WOODBERRY FOREST ADDITIONS SUBDIVISION

APPLICATION NUMBER 5 DATE September 16, 2010

DETAIL SITE PLAN

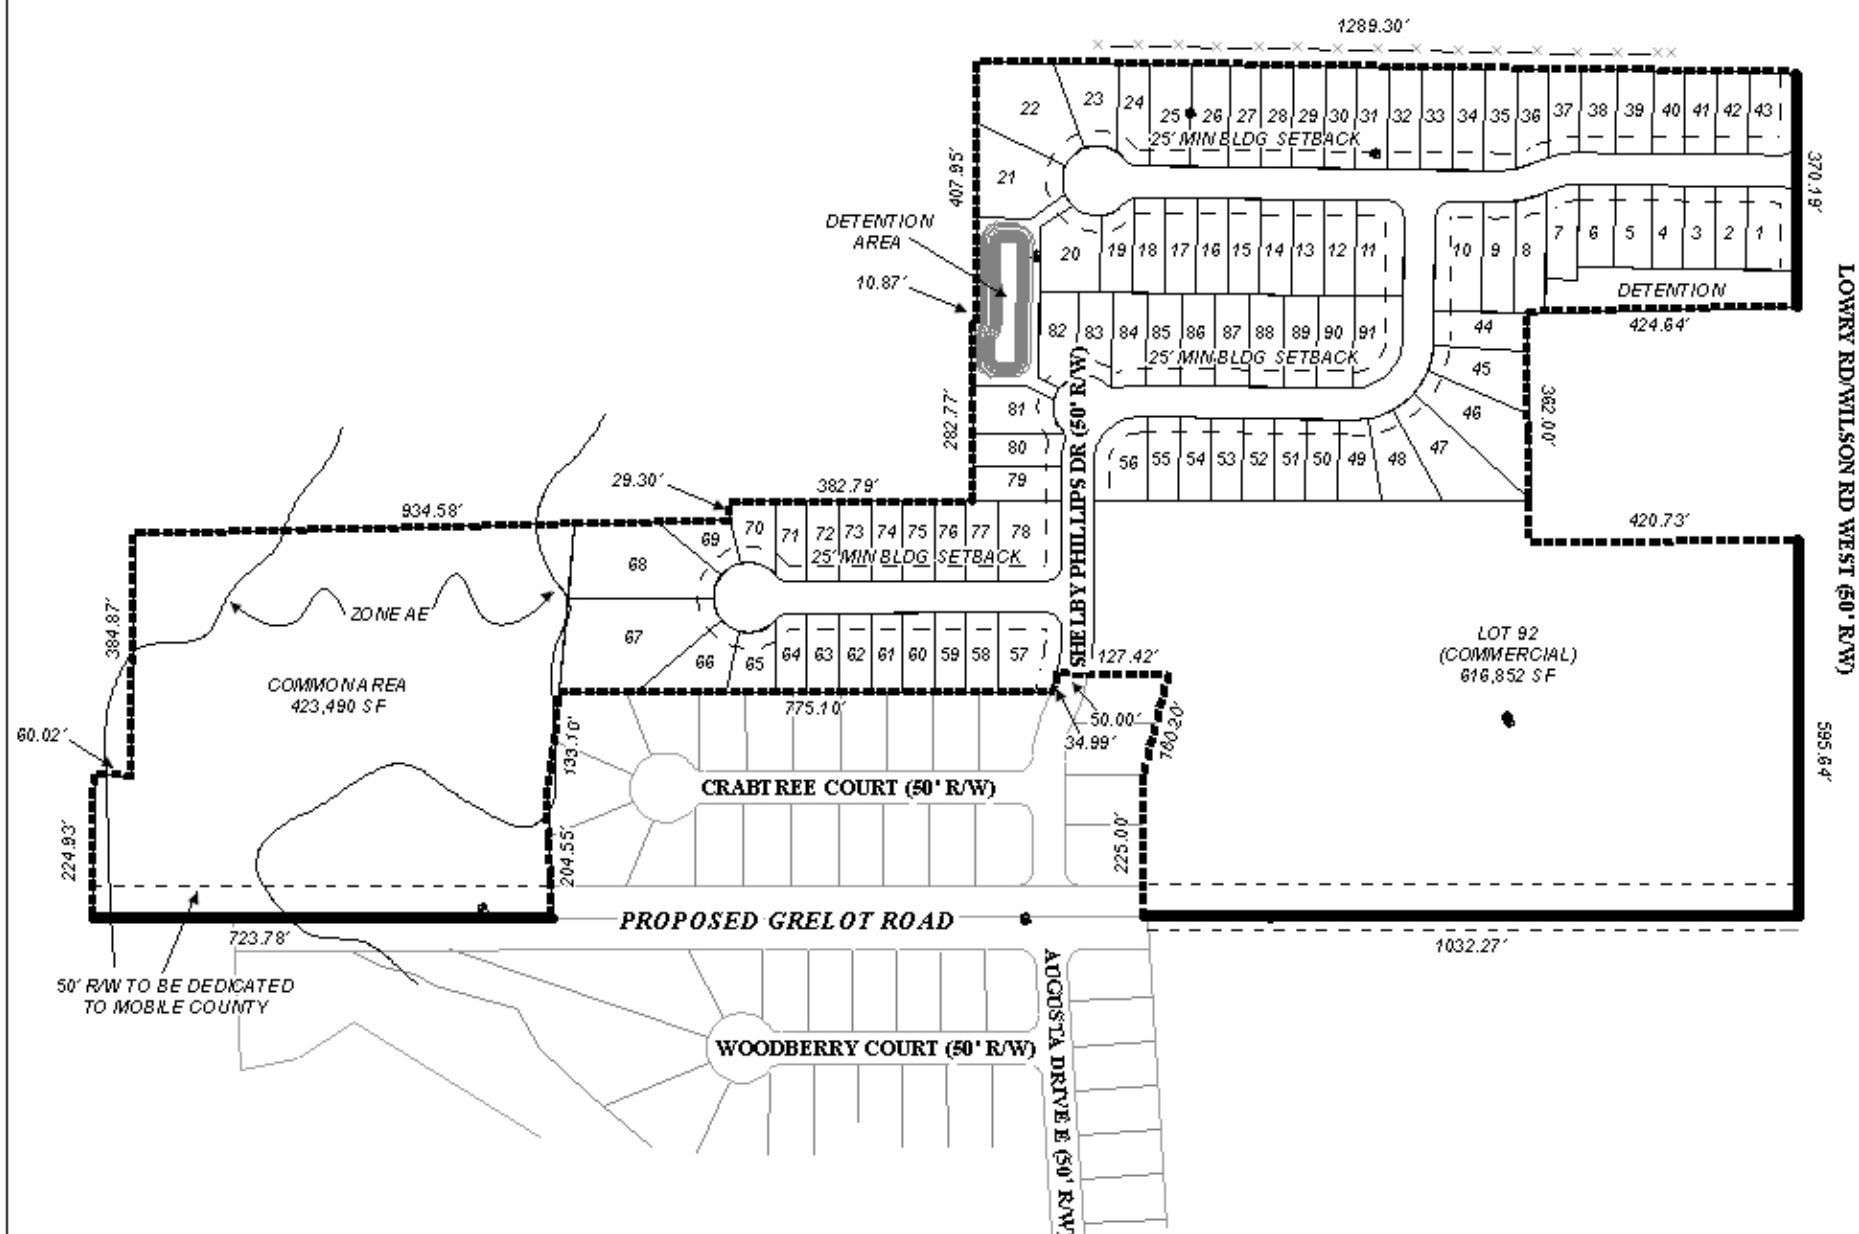
New street construction for this subdivision is proposed, including construction of two cul-de-sacs. Section V.B.14. of the Subdivision Regulations require a cul-de-sac turnaround to have a 120-foot diameter. The Preliminary Plat appears to depict a turnaround diameter of less than 120 feet, however no dimension is shown and scaling can sometimes be inaccurate. The applicant should label the size of the cul-de-sacs, and, if appropriate, modify them to meet the 120-foot width diameter requirement. The other streets appear to have a 50-foot width right-of-way, which meets the basic requirements of Section V.B.14., however, the right-of-way widths are not depicted, and the plat should be modified to depict them.

Access management for the subdivision, if approved, will be a concern given the major streets in the area. The proposed Lots 1 and 43 are corner lots facing the proposed subdivision street and Air Terminal Drive/Wilson Road West. As such, a note on the plat denying Lots 1 and 43 access to Air Terminal Drive/Wilson Road West should be placed on the Final Plat, if approved. All

residential lots should be limited to one curb cut, with the size, design, and exact location of each curb cut to be approved by County Engineering and comply with AASHTO standards. The proposed Lot 92, which is labeled as a commercial lot on the Preliminary Plat, should be limited to one curb cut to Air Terminal Drive/Wilson Road West, and one curb cut to Grelot Road Extension (at such time as Grelot Road Extension is constructed to County standards), with the size, design, and exact location of the curb cuts to be approved by County Engineering and comply with AASHTO standards. Further, Lot 92 is depicted with frontage along the extension of Selby Phillips Drive, which is a residential street. A note should be placed on the Final Plat, if approved, denying Lot 92 access to Selby Phillips Drive.

The 25-foot minimum building setback line is not depicted along all rights-of ways, and the plat should be revised to depict the 25-foot minimum building setback line along all rights-of-way, inclusive of any required dedications.

Based on the preceding, this application is recommended for holdover until the October 21, 2010, meeting, with revisions and documentation due to the Planning section by October 6, 2010, to address the following:

- 1) submission of documentation demonstrating that there is a hardship on the site or that the design is innovative as stated in Section VIII of the Subdivision Regulations;
- 2) revision of the plat to clearly indicate that access to adjacent land-locked parcels is addressed through deeds or public rights-of-way, and provision of supporting documentation;
- 3) revision of the plat to depict required dedication along Air Terminal Drive/Wilson Road West to provide 50 feet, as measured from the centerline of Air Terminal Drive/Wilson Road West;
- 4) revision of the plat to depict dedication sufficient to provide 50 feet for the proposed right-of-way for Grelot Road Extension;

- 5) revision of the plat to depict compliance with Section V.B.16 regarding curb radii for the intersection of Air Terminal Road/Wilson Road West, or submission of appropriate documentation showing that the intersection will be aligned with the roundabout and will not be a traditional intersection;

- 6) revision of the plat to depict 120-foot diameter cul-de-sac right-of-ways;
- 7) revision of the lot layout and size as necessary due to right-of-way dedications and changes;

- 8) labeling of the width of all rights-of-way and cul-de-sacs;
- 9) depiction of the 25-foot minimum building setback line along all right-of-way frontages;

- 10) placement of a note on the Final Plat denying Lots 1 and 43 access to Air Terminal Road/Wilson Road West;
- 11) placement of a note on the Final Plat limiting all residential lots (Lots 1-91) to one curb cut with the size, design, and location of all curb cuts to be approved by Mobile County Engineering and conform to AASHTO standards;

- 12) placement of a note on the Final Plat denying Lot 92 access to Selby Phillips Drive;
- 13) placement of a note on the Final Plat limiting Lot 92 to one curb cut to Air Terminal Road/Wilson Road West with the size, design, and location of all curb cuts to be approved by Mobile County Engineering and conform to AASHTO standards;

- 14) placement of a note on the Final Plat limiting Lot 92 to one curb cut to Grelot Road Extension at such time as Grelot Road Extension is constructed to County standards, with the size, design, and location of all curb cuts to be approved by Mobile County Engineering and conform to AASHTO standards;
